State of Utah
DEPARTMENT OF NATURAL RESOURCES
DIVISION OF OIL, GAS AND MINING

Re: Approval of Reclamation Plans, Mountain Coal Company, Gordon Creek 2, 7, & 8 Mines, ACT/007/016, Folder #3, Carbon County, Utah

TECHNICAL ANALYSIS AND FINDINGS RECLAMATION PLAN

**MOUNTAIN COAL COMPANY
GORDON CREEK #2, #7, #8 MINES
ACT/007/016**

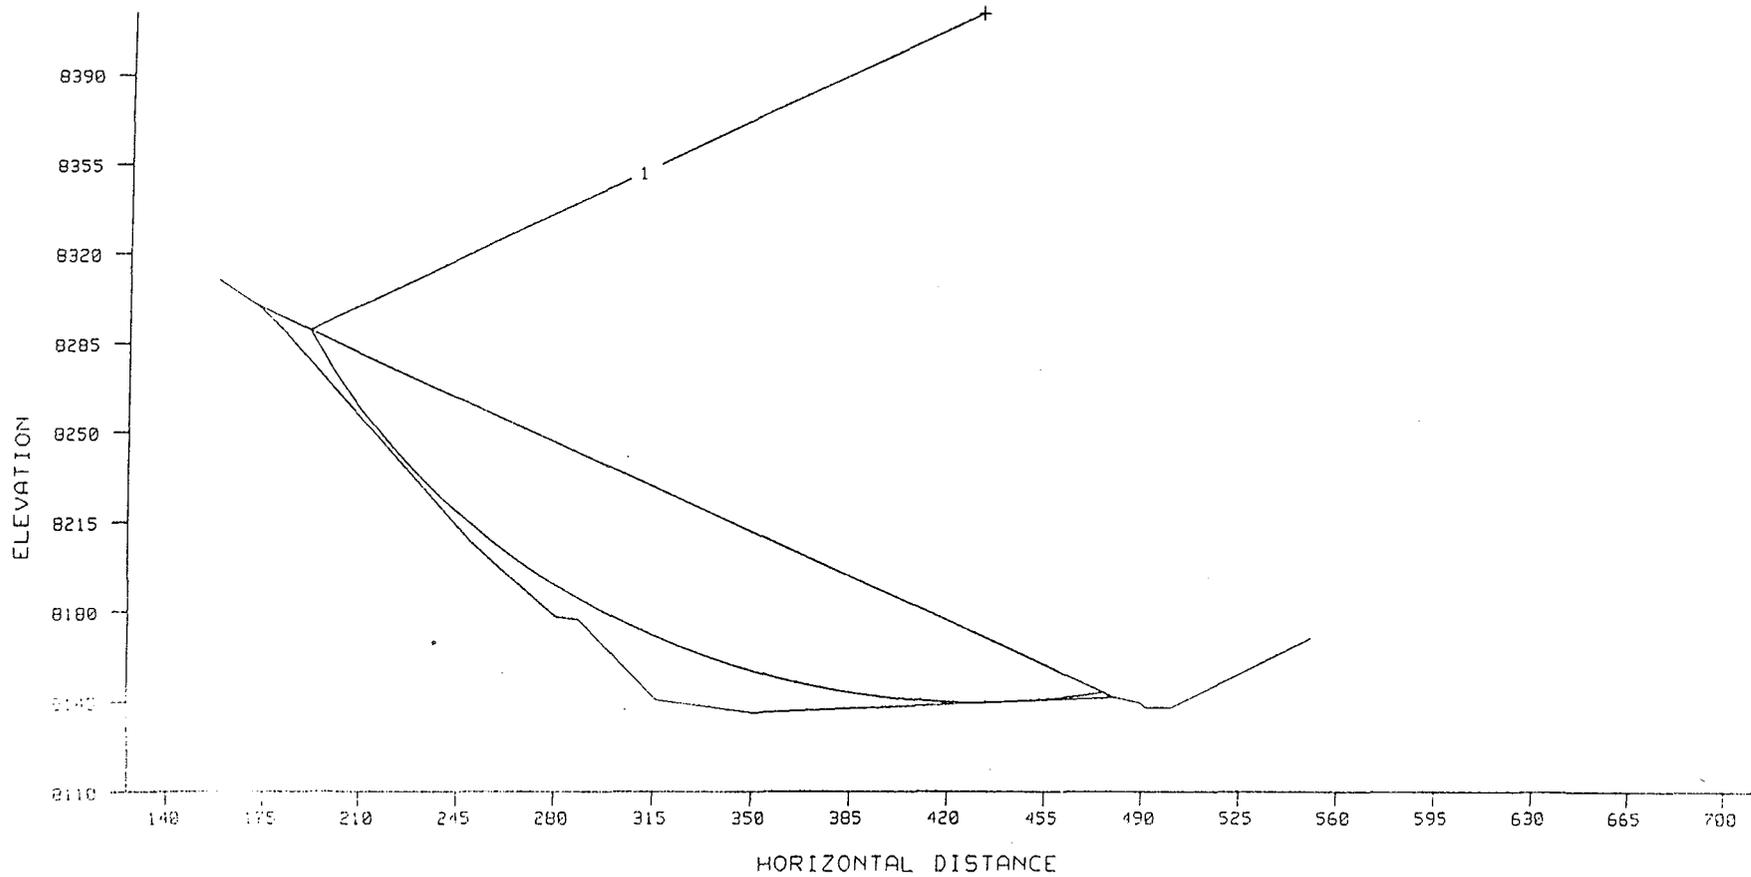
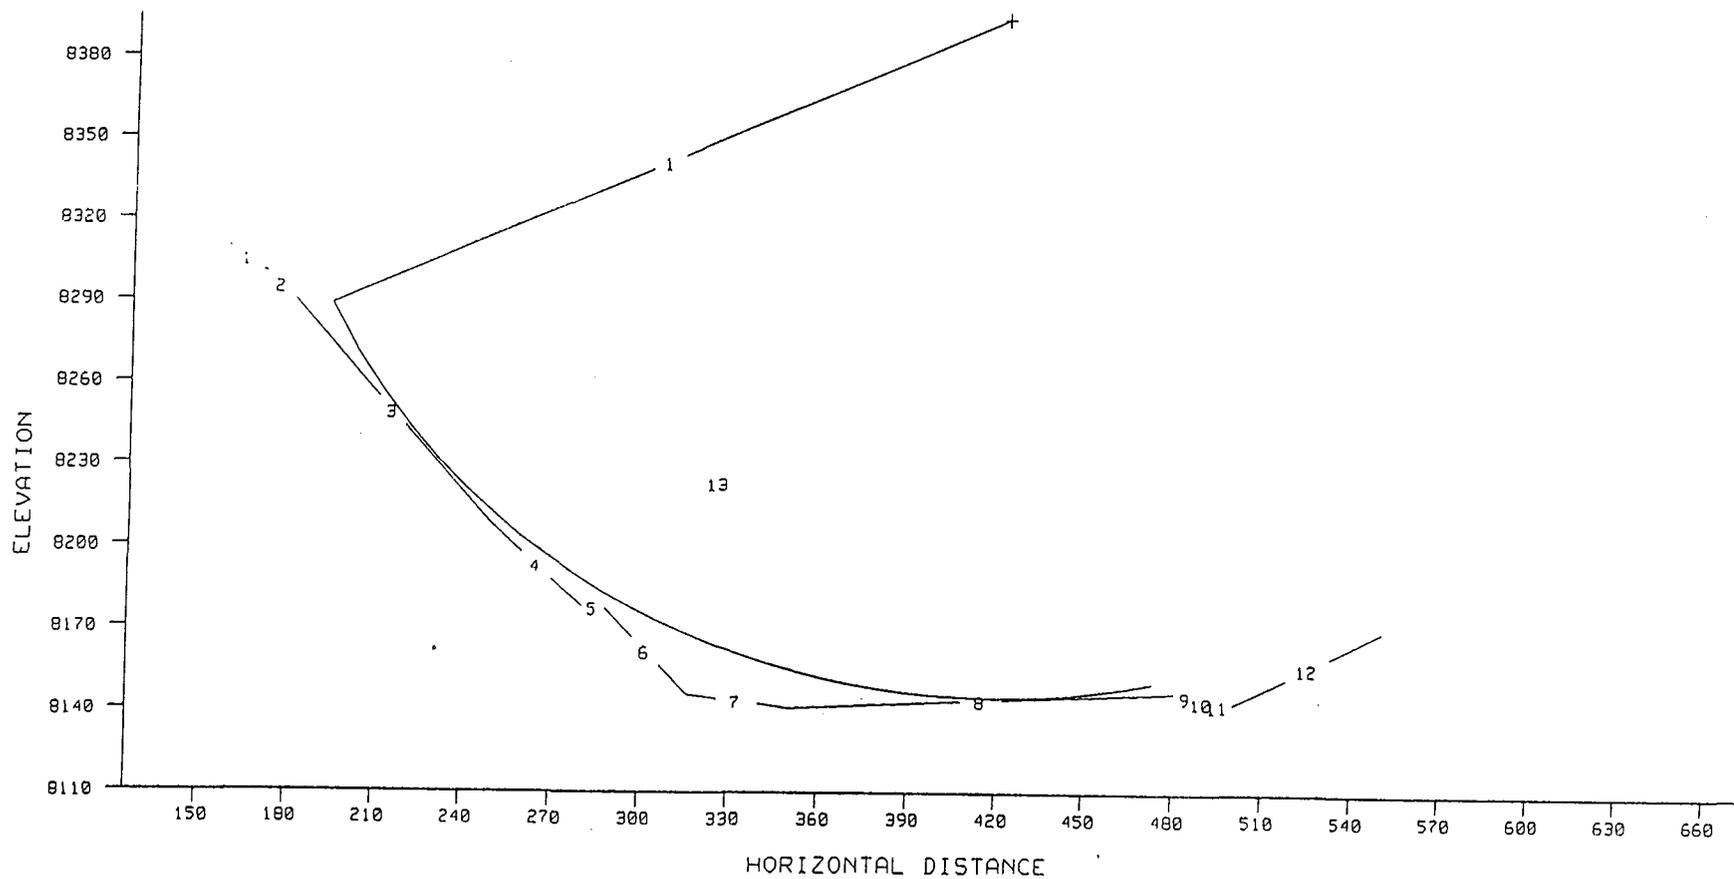
Through modeling and analysis, it was found by the Division that saturated conditions dramatically affect the slope angle and height allowable in comparison to unsaturated conditions where cohesion can be developed. OSM analysis varied the extent to which the fill areas were saturated and theorized that a significant change in the slope could be obtained under certain circumstances. Under certain conditions, the Division agrees that such slopes could be achieved. However, modeling and analysis also indicated that only small changes in the phreatic line (saturation elevation and gradient) would drastically affect these

As an example of the problems associated with the saturation level, a cross section taken from the plan and indicated on the drawings as Section 3 was used to show how saturation can affect slope stability. The soil parameters used in the analysis are taken from the plan and are shown in the sample data labeled as Gordon Creek #7 Portal Area, Saturation limited to top of MSHA bench. This example shows a slope from the top of the cutslope above the portal area projected at the least slope possible, to where it encroaches on the stream channel. The slope shown is a approximately 2:1 slope. Dry, the embankment exceeds a 1.3 FS. The graphic section provided with the example, with a phreatic line projecting from the MSHA bench to the toe of the fill indicates a FS of 1.2. A second graphic, with the slope fully saturated, indicates a FS of .69, resulting in slope failure. Refer to data and figures found in Appendix I to the this technical analysis.

Figure 3 - #7 Portal Area as Proposed, Looking East

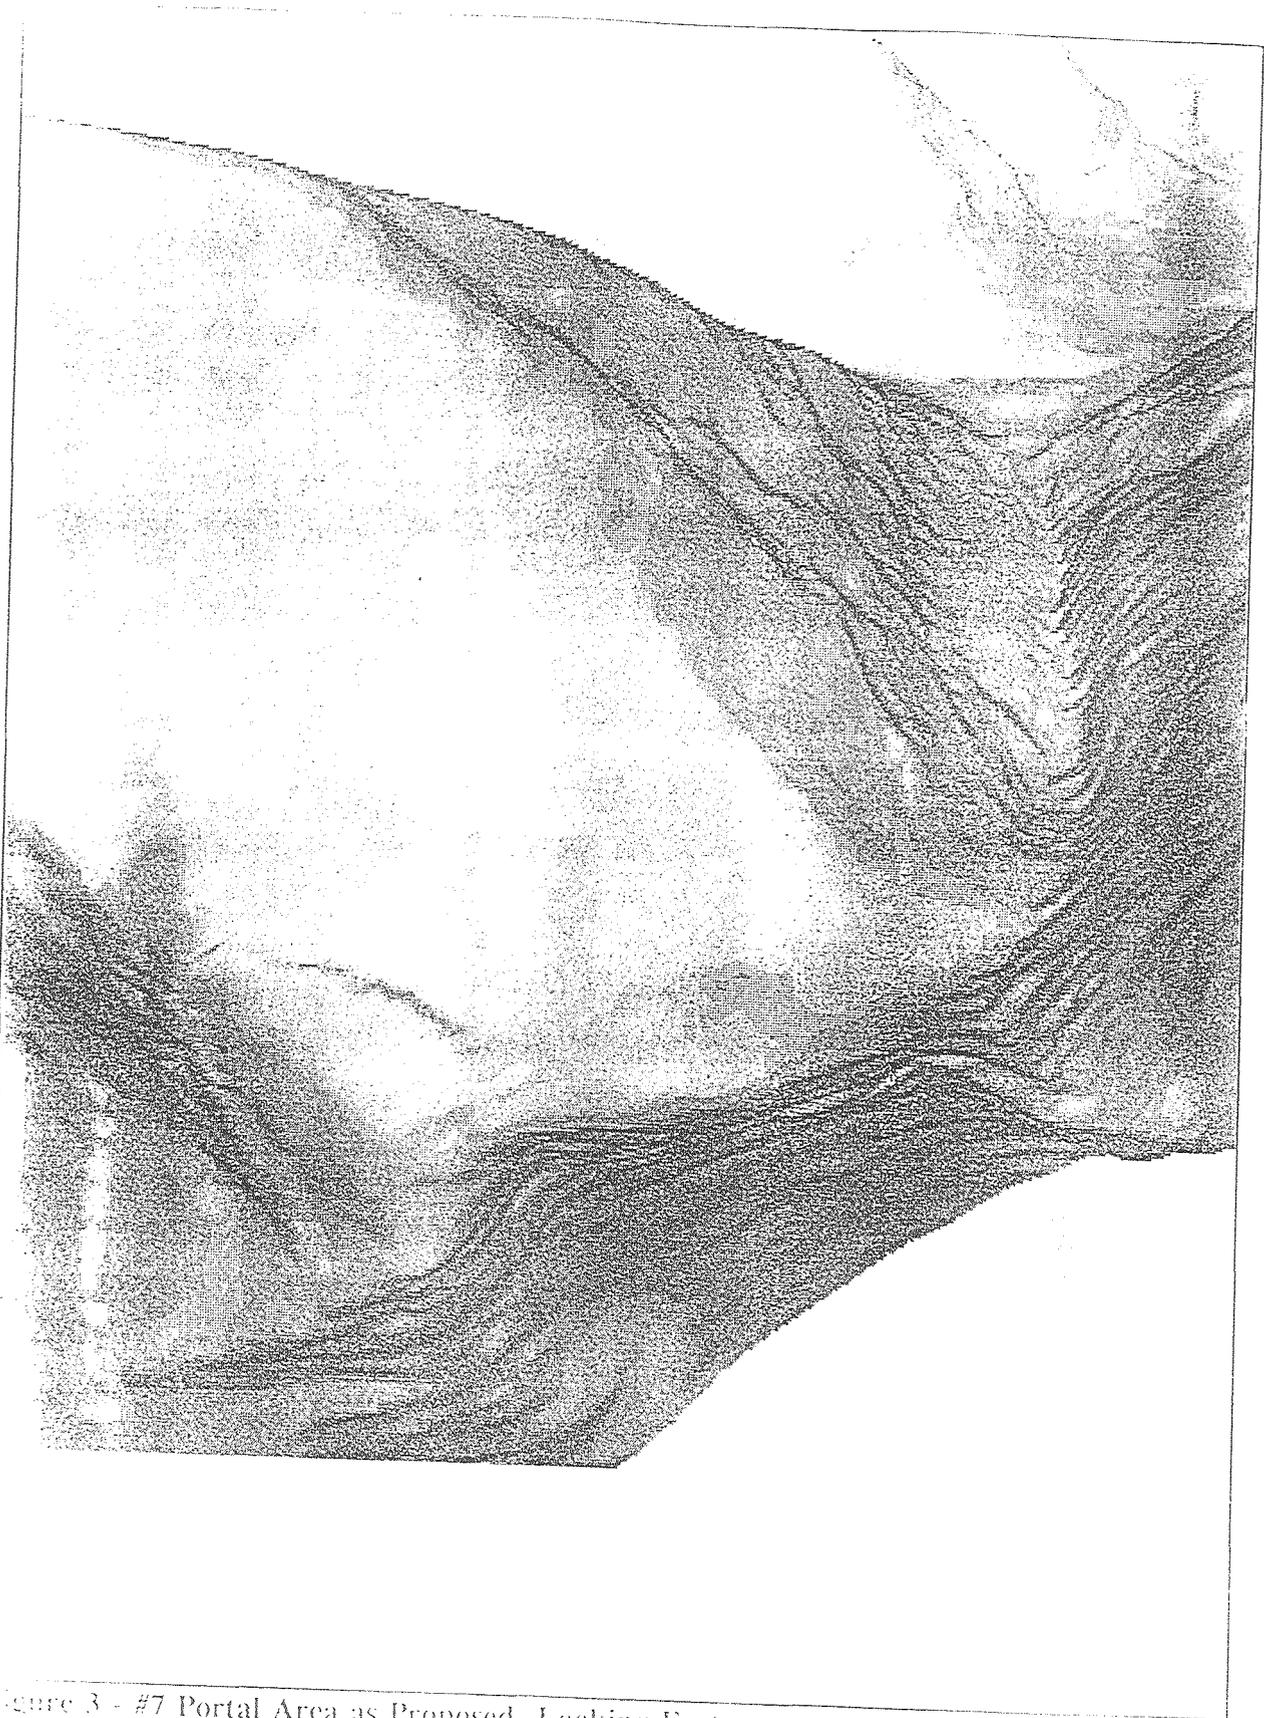
Surface contours within the site were revised by the Division to determine to what extent additional material may be available, within the currently disturbed area, to minimize or further reduce the extent and the height of the cutslopes associated with backfilling and grading. The Division found that material within the site is sufficient to further backfill the #7 Mine portal area to the extent that would be allowed by reducing the factor of safety from 1.5 to 1.3. The revised contours were used only to roughly approximate changes to the entire facilities that would occur. These revised contours, developed approximately 42,000 additional cubic yards of material which could be used for fill within the cutslope areas. Of this, approximately 14,000 cubic yards were used in the #7 Mine portal area with the remainder of the material used in and around the #2 Mine portal area. This material was derived from the gentle slopes adjacent to and to the southeast of the #2 Mine portal area. EarthVision volumetric mass balance calculations from revision of the surface contours are as found in the Volumetrics Report attached to this TA in Appendix I. These calculations only consider the movement of material in comparison to the final reclamation contours proposed by the operator and as such do not relate to the mass balance calculations in the plan used in design earthwork from the mine operation stage to final reclamation. Revision of the proposed surface contours was accomplished by the Division only to determine whether or not additional material could be utilized from within the currently disturbed area.

As part of the backfilling and grading evaluation of the site, the Division considered the elimination or the reduction of cutslopes within the site. The visual effects regarding the placement of additional materials to reduce the vertical extent of cutslopes is not significant in comparison to the final surface configuration as proposed by the operator. To compare the difference, 3-D models looking at the #2 Mine area and the #7 Mine area were developed. Figure 1 shows the #2 Portal area as proposed in the plan while Figure 2 show the site following the relocation of the additional materials. Similarly, Figures 3 and 4, are shown for the #7 Portal area. Unfortunately, digital data was not made available to compare the pre-mining surface configuration or the operational surface configuration to the final reclaimed surface configuration.

Backfilling and Grading, backfilled slopes in the #7 Mine portal area shall be backfilled to the extent possible while maintaining a factor of safety of 1.3. The operator shall determine, based on site conditions, where additional materials may be developed and placed as fill to further reduce or eliminate cut slopes associated with the reclamation plan. Slope measurements and stability analysis based on site conditions during construction shall be provided in conjunction with certified as-built reports or plans demonstrating stability and that backfilling of cutslopes to the extent possible during reclamation activities has been accomplished.
